## 1 - -WSSC Standard Comments for All Plans

Plan # 320170010 - Westwood Shopping Center

WESTWOOD SHOPPING CENTER

SKETCH PLAN

SK2  
320170010

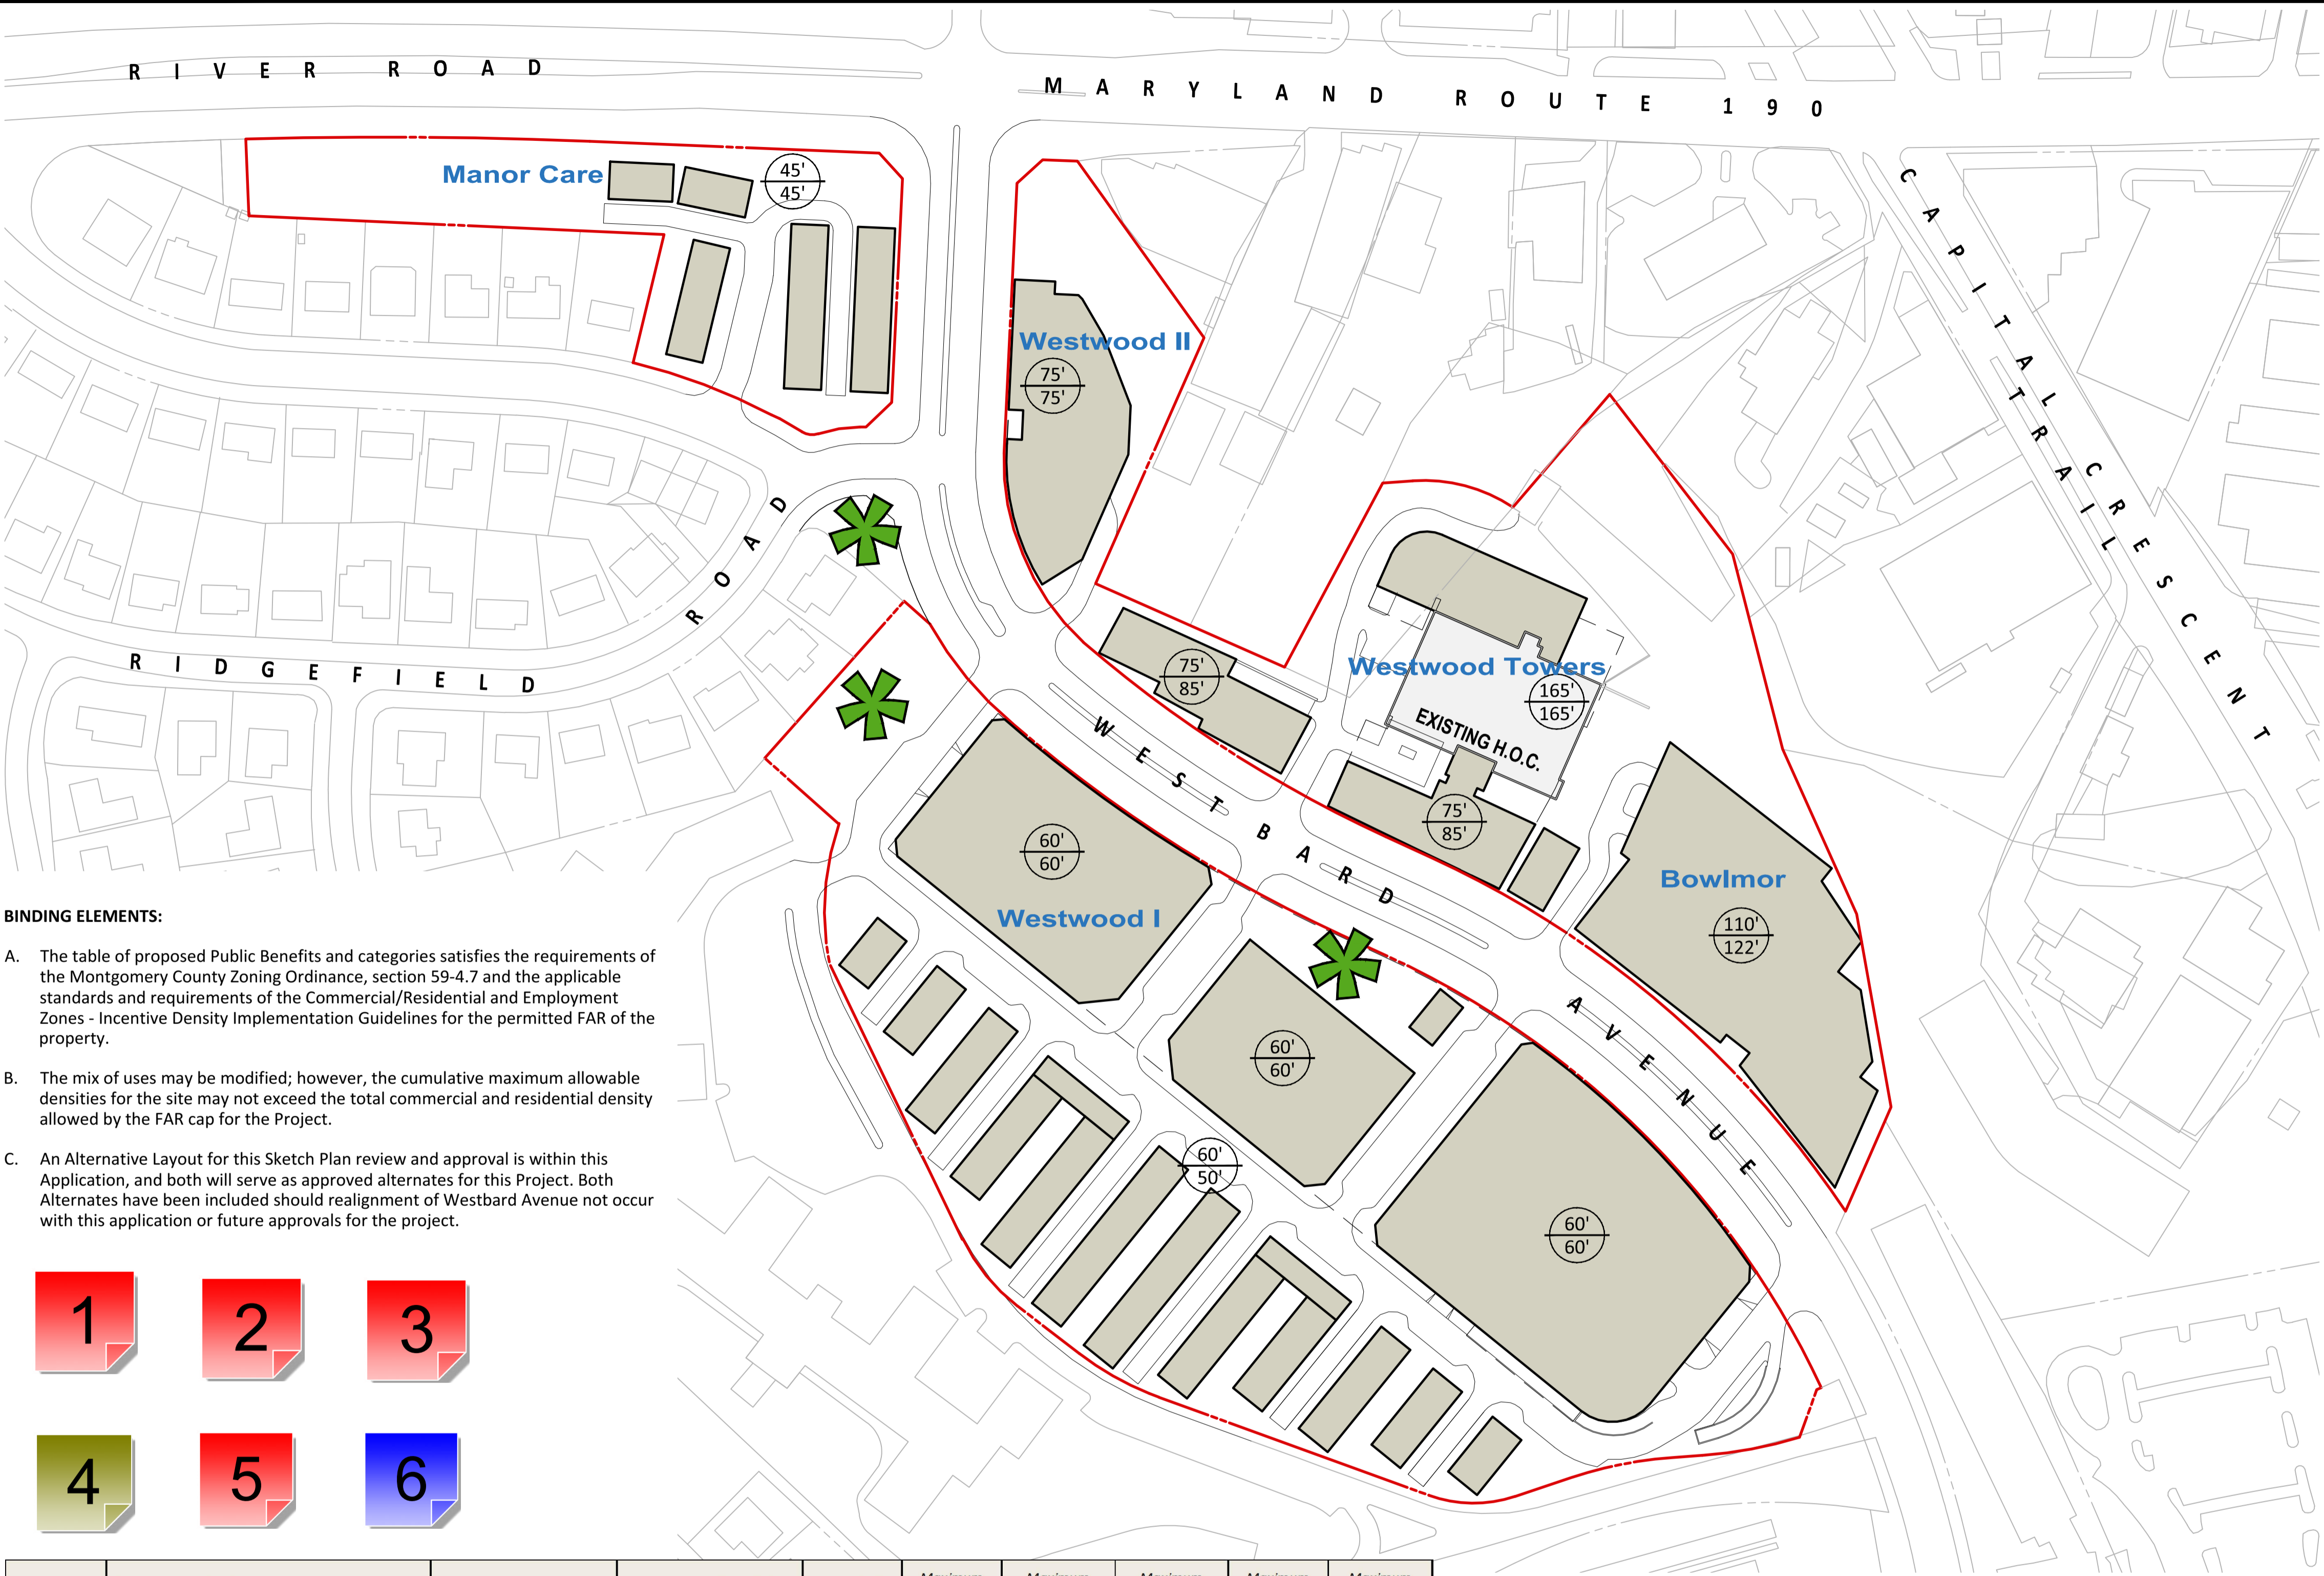
1. Critical Comment - Proposed water mains and service connections are not shown on the plans. Water lines as well as proposed connections need to be included on the plan in order for WSSC to be able to comment.

2. This site is currently being served by existing and active water connection(s).
3. Add the proposed pipeline alignment(s) with water house connection(s) to the plan. Additionally, if easements are required, their limits and locations must be shown.  
\*See WSSC Design Manual C-2.1

6. Existing mains need to be shown on plan and should be labeled with correct pipe size, material and WSSC contract number.
7. Show easement limits on plan for all existing and proposed water mains.

1. Critical Comment - Proposed sewer mains and service connections are not shown on the plan. Sewer lines as well as proposed connections need to be included on the plan in order for WSSC to be able to comment.

2. This site is currently being served by existing and active sewer connection(s).
3. Add the proposed pipeline alignment(s) with sewer house connection(s) to the plan. Additionally, if easements are required their limits and locations must be shown. See WSSC Design Manual C-2.1

4. Existing mains need to be shown on plan and should be labeled with correct pipe size, material and WSSC contract number.
5. Locate sewer service connection(s) to avoid environmental, storm water management facilities, ESD Devices, other utilities, landscaping, tree boxes and structures or paving impacts for future maintenance. See WSSC Design Manual C-3.1

6. Show easement limits on plan for all existing and proposed sewer mains.
7. Locate any sewer pipeline to avoid conflict with large storm drains, culverts, deep side ditches, etc. Maintain the required horizontal clearances from other utilities, retaining walls, sediment traps, street lights, paving, etc. See WSSC Design Manual C-3.1

6. Balconies or other building appurtenances must not encroach within WSSC easements. Water/Sewer pipeline alignment should maintain a minimum 5-foot horizontal clearance from storm-drain pipeline/structures and other utilities. Review of plan submitted does not meet these requirements.
